February 23, 2022

Job Number: 20-11636

Subject: On-Site Wastewater Treatment System
Observations, Donham-Burgess Residence, 27875
US Highway 40, Routt County, Colorado.

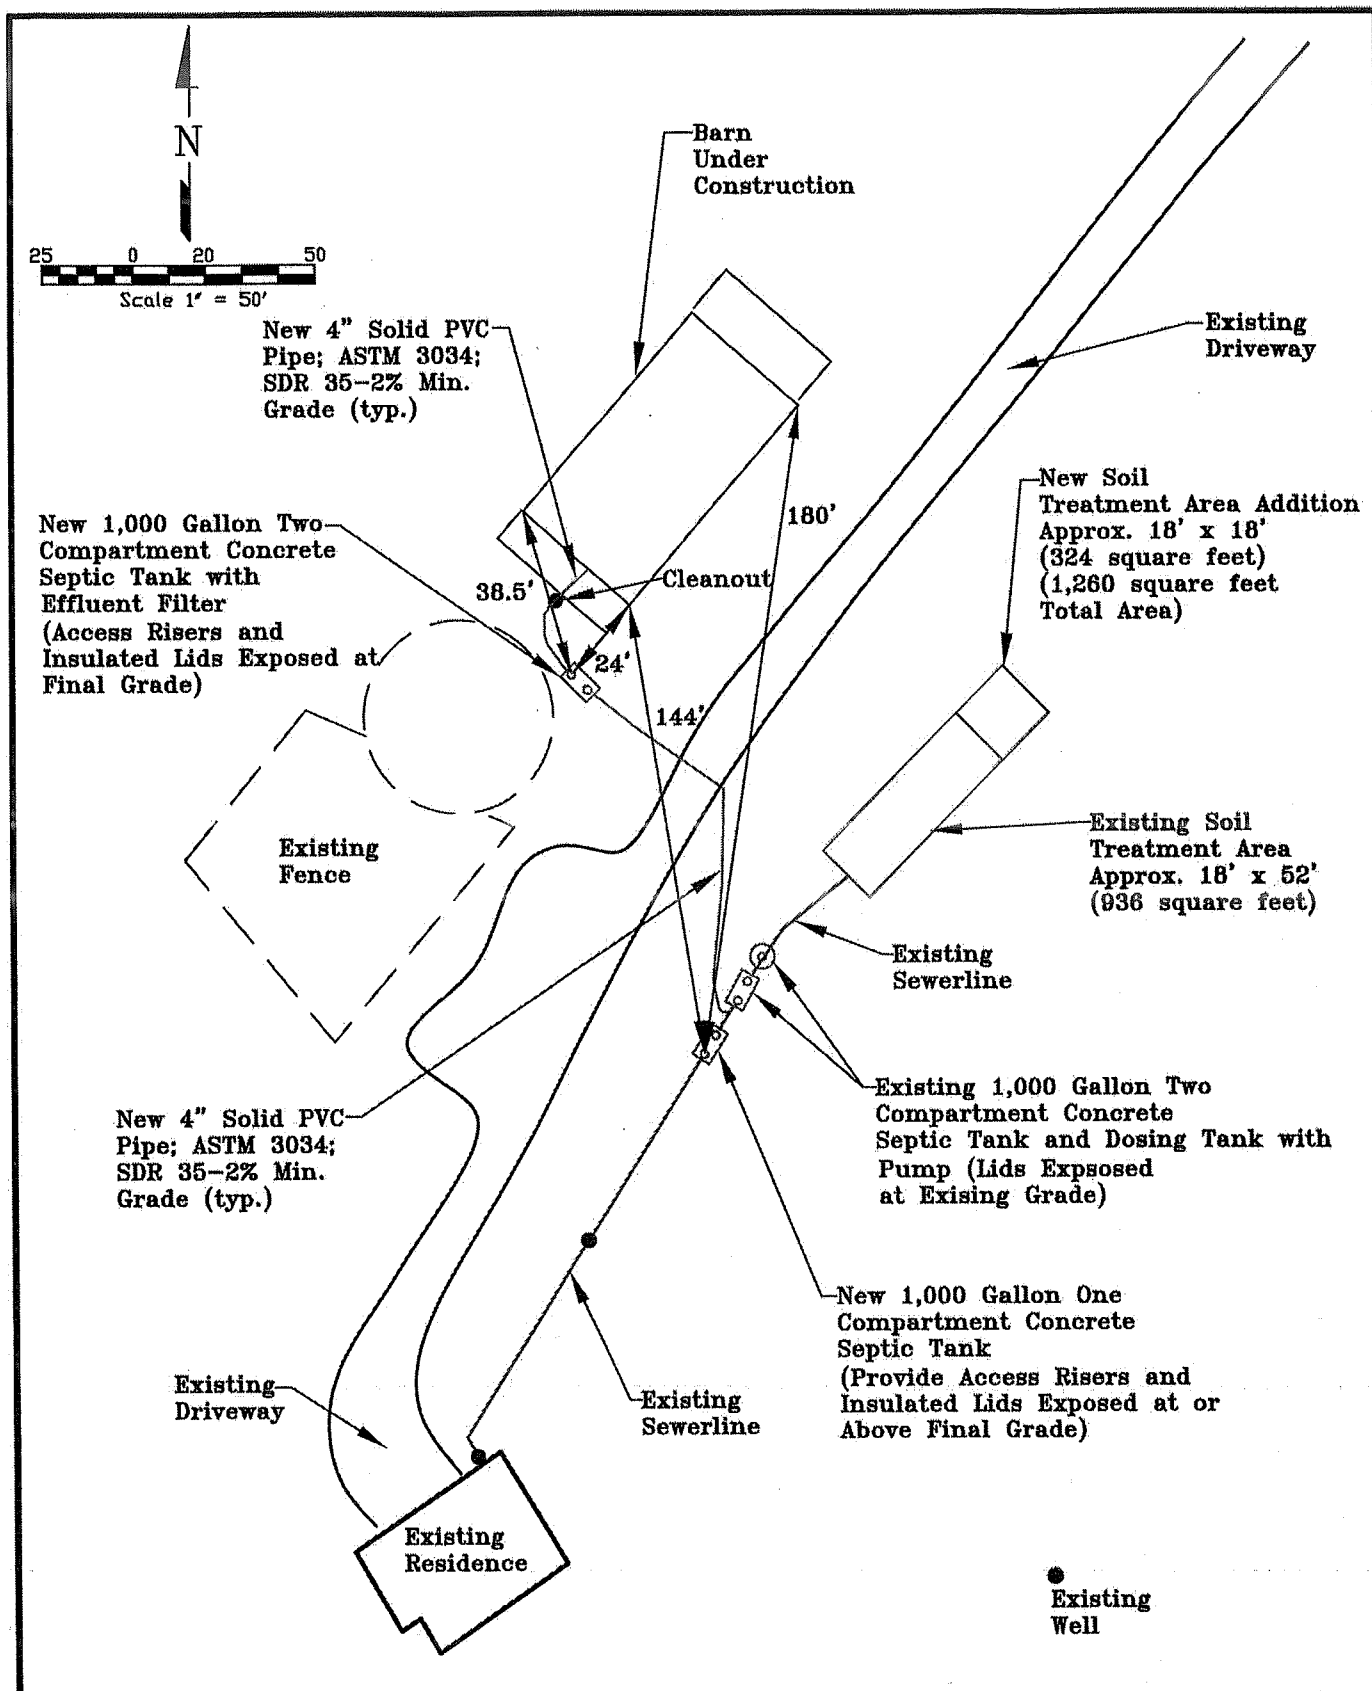
At the time of our site visit on November 10, 2020, the OWTS had been backfilled. It appeared that sufficient cover had been placed over the piping, tanks and soil treatment area. The lids for the septic and dosing tanks were accessible at the finished ground surface. An as-built drawing taken from field measurements of the system is presented in Figure #1.

Based on our part-time observations, it appears that the portions of the system, which were completed and observed at the time of our site visits, had been constructed in general accordance with the design previously completed by our firm, with the noted exceptions. We believe that the system should function properly with proper care and maintenance, as outlined below, if the components backfilled or not completed at the time of our visits were properly constructed. It should also be noted that the STA is larger than required by our design. Based on our calculations, the new OWTS will be adequate for the proposed 5 bedroom residence and barn. In addition, the septic tanks and STA, as constructed, will be adequate for an additional two bedrooms in the barn or added to the existing residence, for a total of seven bedrooms.
